STAFF RECOMMENDATION
4411 Park Avenue
August 15, 2018

Application: New Construction—Addition
District: Park and Elkins Neighborhood Conservation Zoning Overlay
Council District: 24
Map and Parcel Number: 09116004100
Applicant: Eric and Carina Jolly
Project Lead: Sean Alexander, sean.alexander@nashville.gov

Description of Project: The applicant is proposing to enlarge the house with a rear addition.

SHEET NUMBER
A-1

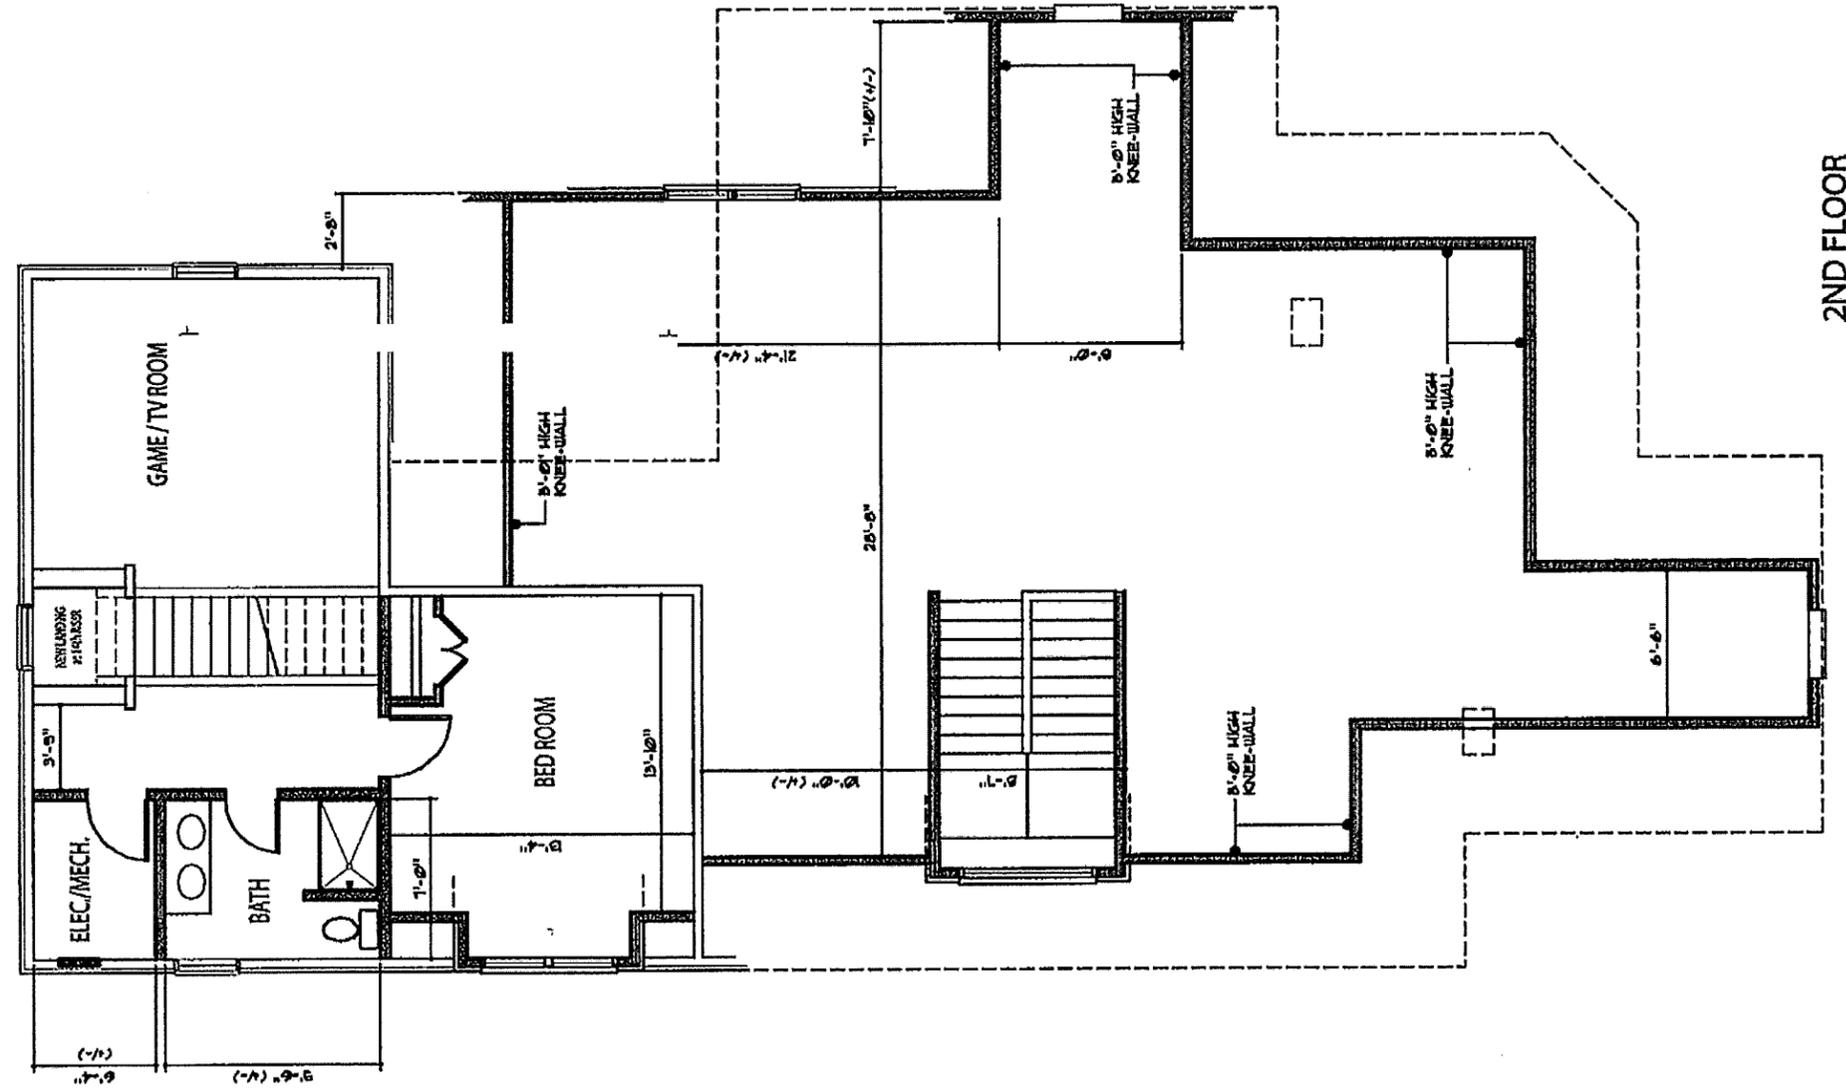
Location & Removability: The new addition will be located behind the rear of the historic house, tying in to the side of the existing addition and in to the rear slope of the original roof. The addition will be stepped in from the right side of the house by one foot (1') and go back with a two foot (2') deep alcove before stepping back out to the right. The existing rear addition is flush with the left side of the house, and no change to its footprint on that side is proposed.

At the first story level behind the existing building, the new addition will step out to the right side of the existing side wall five feet (5') wider than the historic house. Staff finds the additional width to be appropriate because it originates behind the rear of the original structure and because the lot is wider than the standard lot size for the area. The lot is sixty-one feet (61') wide.

SHEET NUMBER
A-1

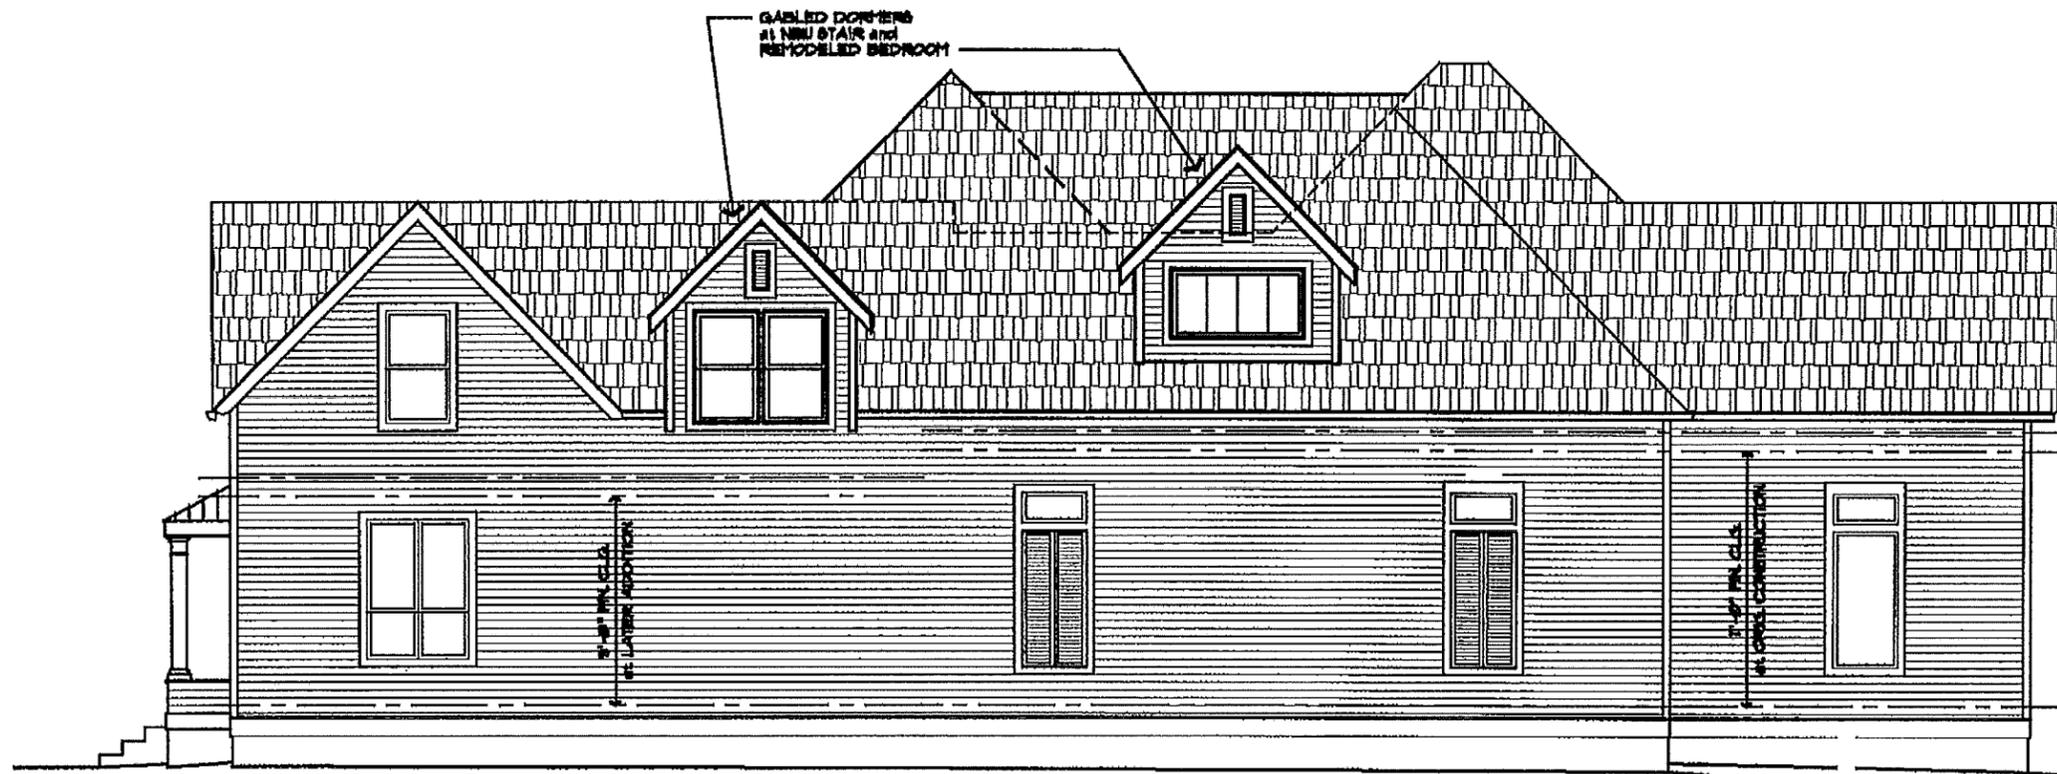
The addition will also include two dormers on the left side of the house, one on the original roof and one on the roof of the earlier addition. Both of these locations would be appropriate for dormer additions, however Staff recommends that they are set two feet (2') in from the first story wall below and down off of the original roof ridges so as to not impact the original roof lines.

Roof form: The addition’s roof will have two gables facing to the right, matching the 12:12 pitch of the original roof and the existing addition. As described above, two dormers are to be added on the left side of the house, which would also be gabled with a 12:12 pitch. The porch roof will have a 6:12 pitch, which is typical of the roofs on similar porch forms.

With a condition that the dormers are revised to fit within the plane of the roof, Staff finds that the location of the addition is appropriate and that the project meets sections II.B.2.a and II.B.2.e of the design guidelines.

With a condition that the new left side dormers are revised to fit within the plane of the roof, Staff finds that that the roofs of the proposed addition are appropriate and that the project meets section II.B.1.e of the design guidelines.
